CALIFORNIA COASTAL COMMISSION

REGULAR CALENDAR
STAFF REPORT AND PRELIMINARY RECOMMENDATION

Application No.: 6-98-121

Description: Implementation of Mission Bay Shoreline Protection, Phase III, including: extension of existing rip rap revetment by 30 linear feet with 550 tons of rock at southwest portion of Mariner's Point; installation of drainage pipe and recontour of beach at Ventura Cove; recontour of beach at Northwest Vacation Island; rehabilitate an existing 750 lineal foot section of rock rip rap revetment including installation of filter fabric and 5,220 tons of rock at Vacation Island, South Cove; reconstruction of West Ski Island with armorflex perimeter and 13,900 cu. yds. of dredging to create cove area for boats; and recontour of Paradise Island with approximately 1,600 cu. yds. of sand.

EXHIBIT NO. 2
APPLICATION NO.
6-98-121
Site 3
Mariners Point

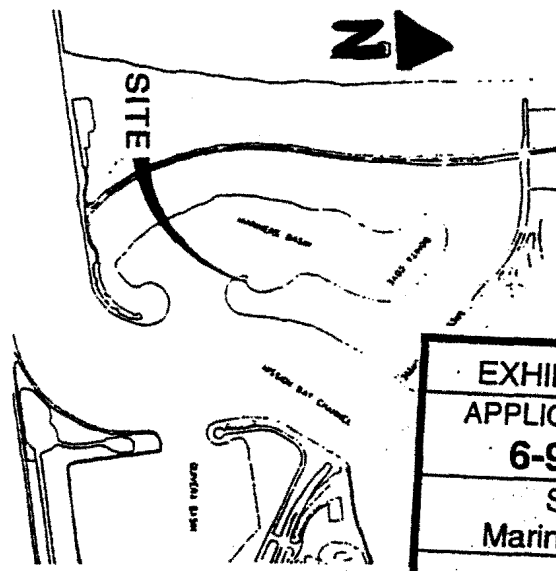
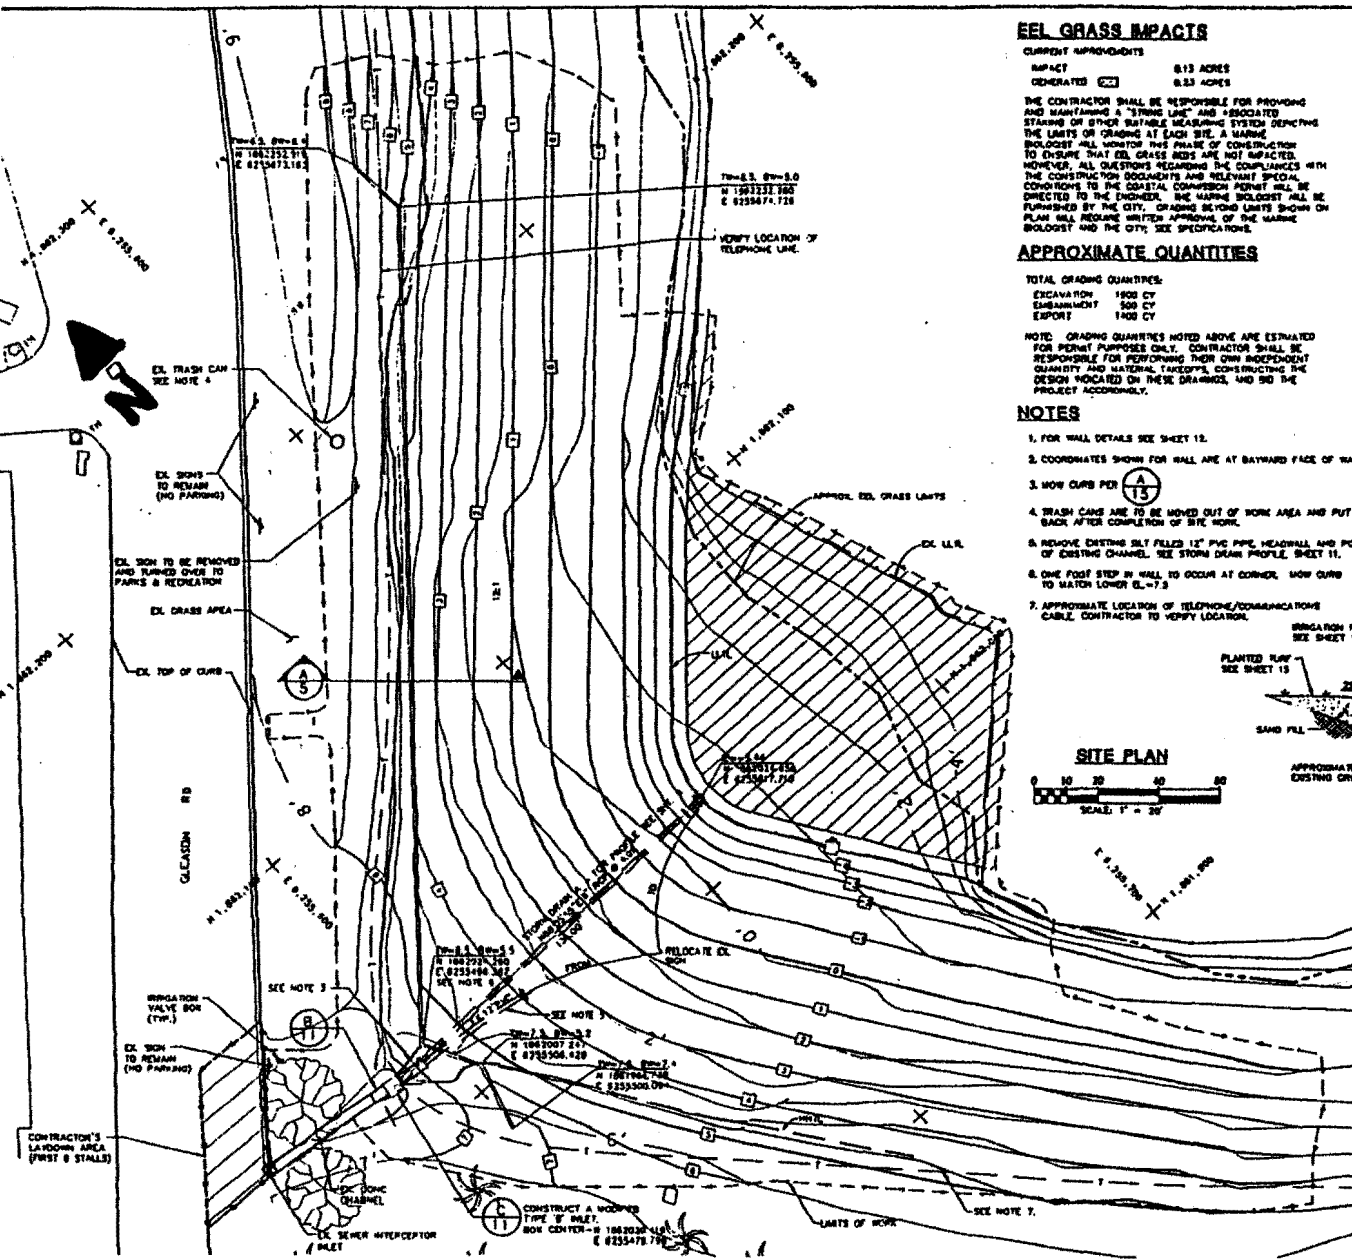
As noted in the project description, erosion at this location has occurred due to high wave events. Although the majority of the point is armored, the area of beach used as a Least Tern Colony is in danger as the fence and existing rip rap has been undermined. This site is unique and distinct in that the beach functions as an environmentally-sensitive habitat area because it is used for nesting and habitat by an endangered species – the California Least tern. The proposed rip rap revetment is intended to protect the least tern area only and not other public beach area located on the point. The rip rap revetment will be convex in shape rather than concave in shape which would follow the contour of the escarpment and upper sandy parkland inland of the point in order to more appropriately reflect wave energy. As noted by the City's representative, if the rip rap had been designed to "hug the toe of the slope" in a concave shape, it would have focused energy back into a single point whereas a convex wall reflects it in a broader array (reference Exhibit No. 2).

It should also be noted that a low intertidal beach area will be left between the rock and Mariner's Basin at the transition area of the revetment. Therefore, in this case, the Commission finds that the proposed rip rap revetment is required to protect an existing beach from erosion and is therefore consistent with Coastal Act Section 30235.

EXHIBIT NO. 6
APPLICATION NO.
6-98-121
 Site 25
 West Ski Island

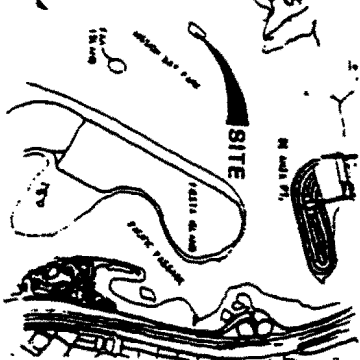
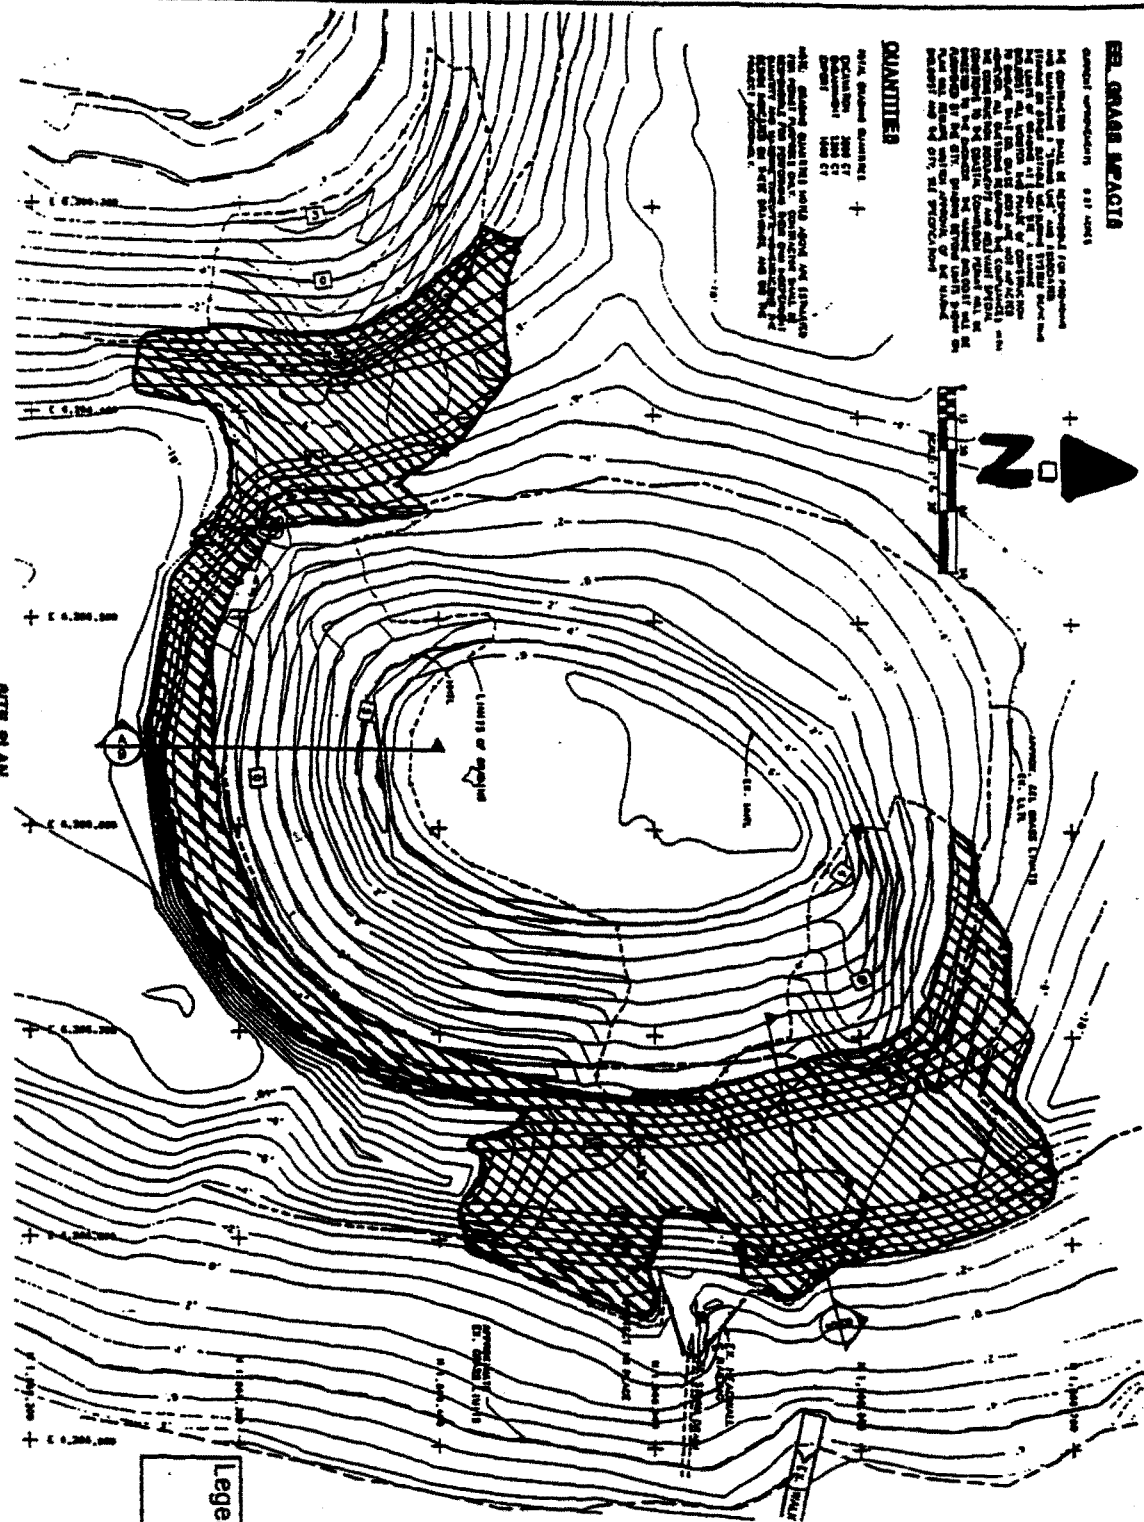
1. Project Description. Proposed is to create an armored island with an internal beach to protect the island from continuing to erode. In order to accomplish this, the island will be graded in size to that which existed in approximately 1995. The island will be reshaped and will include grading consisting of approximately 13,900 cy. of existing on-site sand in a balanced condition. The proposed armoring will comprise approximately 5,600 square yards of filter fabric and 50,000 square feet of Armorflex. (reference Exhibit 9). West Ski Island is located just east of the Crown Point Shores beach area.

2. Shoreline Protective Devices/Geologic Hazards. The reason that shoreline protection is needed at this location is that the island will continue to erode if nothing is done to protect it. As noted by the City, one of the alternatives is to do nothing; however, the City believes if nothing is done, the bay will lose a landmark and valuable recreation site. The City has indicated that without some type of measure to correct the erosion, the island will become like East Ski Island which was a navigational hazard which had to be removed through dredging in Phase I of the shoreline stabilization project. In addition to the loss in terms of a landmark and recreation, there would also be a loss of intertidal and mudflat habitat if the island were allowed to completely disappear. In 1990, other alternatives were considered in the original project plan which called for the grading of a 50-foot wide coarse-grained beach or the placement of a bulkhead wall with a beach below. However, since that time, the island has eroded away from over 4 acres in size to less than 1 1/2 acres in size above the mean high water line at an elevation of 2.73 MSL. If no shoreline stabilization is implemented for this site, the island will become an over-wash shoal by the year 2005 (reference Exhibit 8).

Commission staff has asked the City to consider other alternatives that will not result in armoring the island with a hard structure. However, the City has indicated that this is the best method of shoreline protection, otherwise the island will disappear altogether and would ultimately have to be dredged and removed. However, alternatives which may require more frequent maintenance but have less environmental impacts have not been fully explored by the City. The project should be the least environmentally-damaging alternative and balance the impacts to public recreation, eelgrass habitat, bird foraging and visual quality. Commission staff is therefore recommending that this aspect of the proposal not be authorized at this time. The City should thoroughly analyze other alternatives including, but not limited to, regrading the island with use of fine grain sand and more frequent maintenance to protect the island from further erosion. The installation of a hard shoreline protective device such as armorflex reduces the amount of shoreline of the island accessible by boats and has the potential to create accelerated erosion in other parts of the bay due to the anticipated increased wave reflection. It represents a structure in the middle of the bay, where an island that responds more naturally to the wave environment currently exists. Therefore, the subject proposal cannot be found consistent with Section 30235 of the Act without more thorough analysis of alternatives.

4. Public Access/Recreational Use. Although the island has greatly diminished in size, presently it can be accessed from all sides via boat as it is devoid of any shoreline protection. Commission staff remains concerned that by armoring it in a horse-shoe shape fashion with an internal beach in the middle, access to the island will be greatly minimized. Also, there remains concerns with regard to skiers and recreational boaters who may accidentally run into the armored island. Such a collision would be much more severe than with the presently unprotected island. Therefore, the Commission finds that the proposed reconstruction of the island cannot be found consistent with the public access and recreation policies of the Coastal Act. For this reason, this aspect of the proposal is not hereby authorized, pursuant to Special Condition #1.

1. Revised Plans for Site 25 – West Ski Island. Prior to the issuance of a coastal development permit, the applicant shall submit revised plans to the Executive Director for review and written approval which:

- a) Delete the proposed reconstruction of West Ski Island and installation of Armorflex;
- b) Other solutions to remedy the erosion at this location may include regrading the island with importation of sand and more frequent maintenance or other measures which do not incorporate a hard structure (i.e., armorflex, bulkhead walls or rip rap revetment) through a future coastal development permit.
